DESCRIPTIVE REPORT

Watch Hill Point

SPECIAL REPORT - SPECIAL PROJECT 1-63 - PRESURVEY REVIEW

Review - Field Examination No. 3, 1963 Sugar Reef Passage - Block Island Sd., R. I.

4. Comparison with Chart 358 (Latest Print Date 7-7-64)

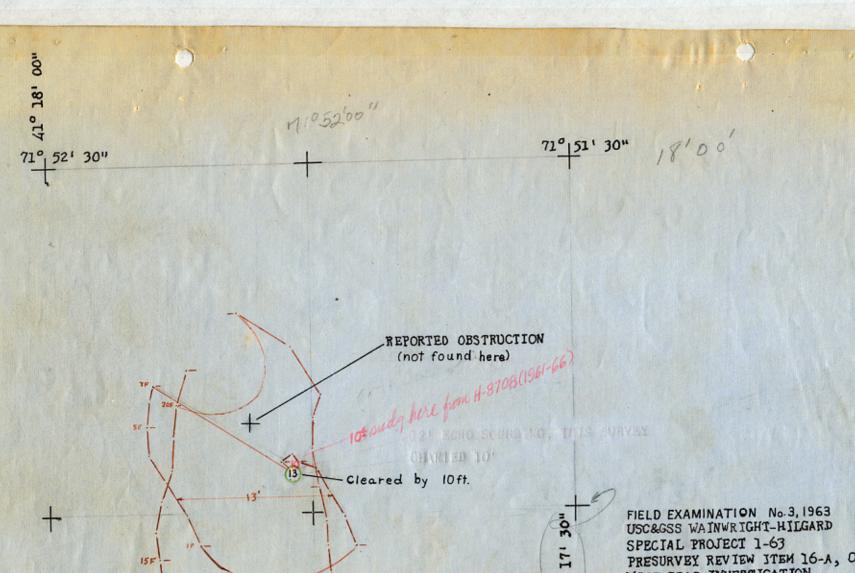
Minor differences of 1-2 ft. are generally noted between the charted and present survey depths except in several instances where greater differences occur because of slight displacements on steep slopes.

Attention is directed to the following discrepancies between the charted soundings and the effective wire drag depths of the present survey.

a. The 12-ft. sounding charted in lat. 41°17.53', long. 71°52.08'4,8 from chart letter 1259 (1962) was cleared by a wire drag of the present survey set to an effective depth of 13 ft. However, the 12 ft. is not considered disproved and it is recommended that it be retained on the chart.

FE 3, 1963 - 2 34.2 The 10-ft. sounding charted in lat. 41°17.57', long. 71°52.031.8 from H-8708 (1961-62) prior to verification and review, was revised to 11 ft. during verification of H-8708. The 10-ft. sounding charted in lat. 41°17.55', long. 71°52.03' from chart letter 1259 (1962) was cleared by a wire drag of the present survey set to an effective depth of 13 ft. The charted 10-ft. sounding is believed to be plotted out of position and should actually fall about 46 meters to the northward where a 11 ft. sounding falls on H-8708 (1961-62). The charted 10 ft. should be deleted from the chart. The Descriptive Report covers all other matters pertaining to this examination. No further discussion is considered necessary. Reviewed by F. R. Scarcella 1/8/65 Inspected by I. M. Zeskind * This 11 ft depth at lat. 41° 17.57' long. 71°52.03' was deleted out _____ ne placed with a 10 ft depth (10th ft) during inspection of H-8708.
